# UNITED STATES PATENT AND TRADEMARK OFFICE

APPLICATION NO.	FILING DATE	FIRST NAMED INVENTOR	ATTORNEY DOCKET NO.	CONFIRMATION NO.
10/721,327	11/26/2003	Jiro Iizuka	018842.1279	8377

<b>Office Action Summary</b>	<b>Application No.</b> 10/721,327	<b>Applicant(s)</b> IIZUKA ET AL.	
	<b>Examiner</b> Samuel E. Belt	<b>Art Unit</b> 3746

## DETAILED ACTION

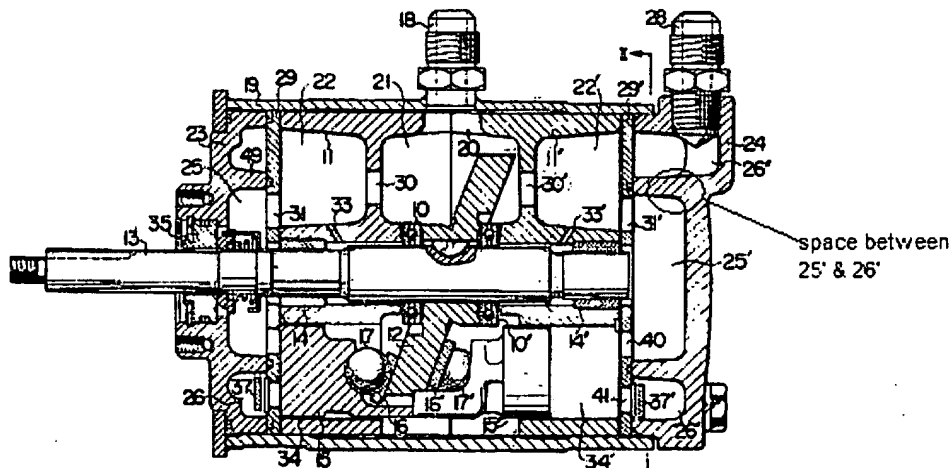
Kishi et al. in Figure 1 teaches a compressor comprising a compressor housing (11', 19) a plurality of cylinder bores (34, 34') made in the compressor housing (19) and spaced from one another in a circumferential direction of the compressor, a plurality of pistons (15, 15') reciprocally movable in the cylinder bores (34, 34') respectively, and a cylinder head (24) opposite to one end of the compressor housing and defining a refrigerant suction (25') chamber and a refrigerant discharge chamber (26') each of which communicates with the cylinder bores (34, 34'). The cylinder head (24) having a space located between the refrigerant suction chamber (26') and the refrigerant discharge chamber (25'), (**See Note**).

In the refrigerant compressor, the suction chamber (25') is at a radially center area of the cylinder head (24) while the refrigerant annular (see Figure 2) discharge chamber (26') is at a radially outer peripheral area of the cylinder head (24).

(Note: see the dividing wall that spaces chamber (25') from chamber (26') as illustrated in Figure 1 below.

Applicant's arguments filed 03/21/2006 have been fully considered but they are not persuasive because the term "space" is defined from Dictionary.com as being anything that separates or keeps apart. The dividing wall shown above clearly defines a

separation between chambers (25') and (26'), and therefore is still being considered a "space".
